OPTICAL RADAR ANGLE TRACKING MOUNT

RADC-TR-73-205 ADDENDUM
Final Report
September 1974

RADC COMMENTS AND FECKER SYSTEMS REPLY
ON
FINAL REPORT

Figure 7.

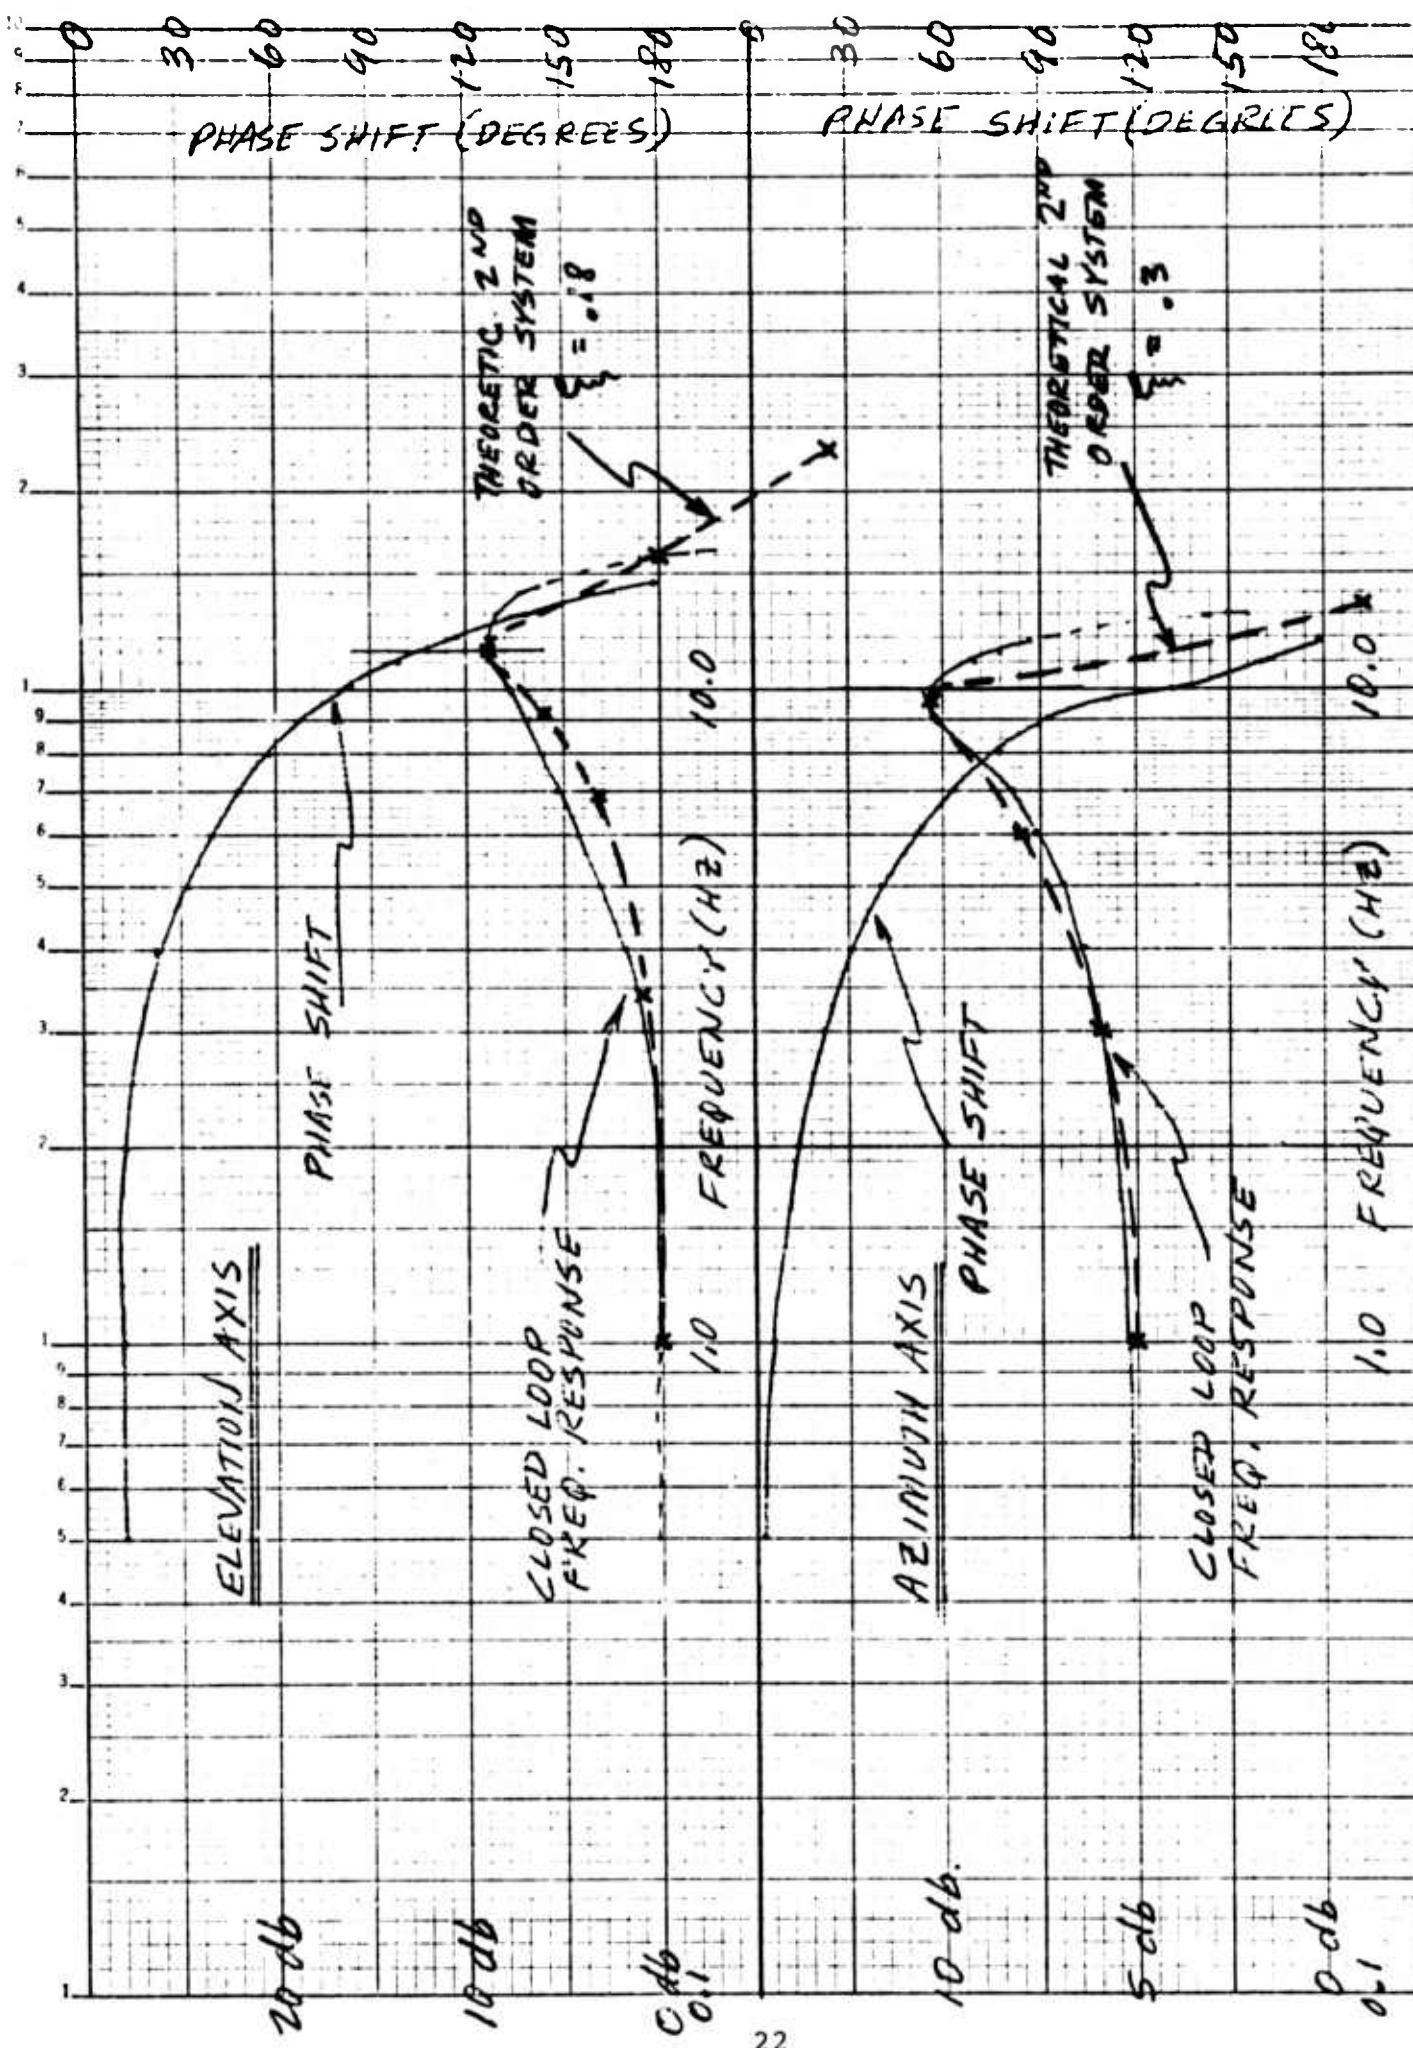
4. Servo bandwidth response does not show a classical trend with increasing frequency:

The servo gain plots for both Az and El servos do not indicate the classical downward trend with increasing frequency. The steady increase in gain up to the mount resonance implies that this data was taken while not monitoring the proper test point for servo response. The data trend more accurately follows the expected response of a servo compensation network which corrects for gain rolloff with increasing frequency. The data trend for the servo gain needs to be explained by FSD as to this steady increase up to the mount resonance points, and, why the unusual peaking at 0.5 Hz as displayed in the data on page 117 for El axis was not entered in the plots on page 116. Characterization of the servo is critically important for transfer function definition and position-rate control via computer drive as applied to precision tracking efforts which will be occurring during a later date at CORAL.

RADC's interpretation of the rate loop servo response curves is somewhat incorrect. The plot shown is the solution to the classic servo transfer function:

To aid the following explanation of how to readout a Status Word #1, a copy of the Compugetics Status Word description has been included as Figure 1 and has been improved by the addition of details.

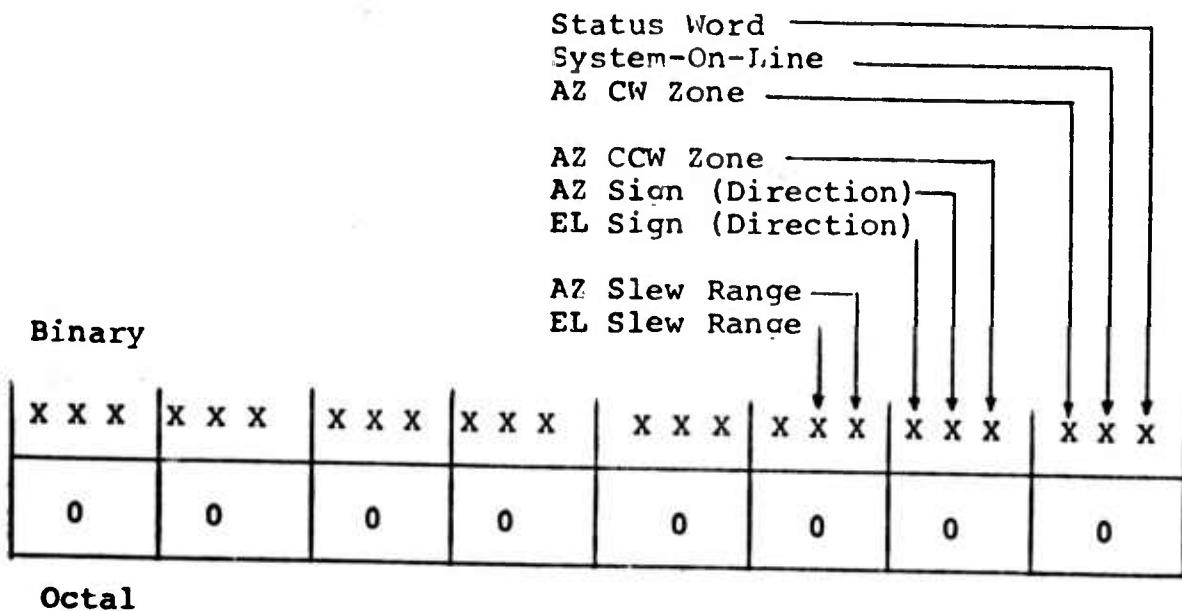
The status word displayed on pages 147 and 148 do not verify the required CW or CCW zone entry as the test required. This function is critically important for software/programming knowledge of mount position to prevent driving the mount into the limit stops.
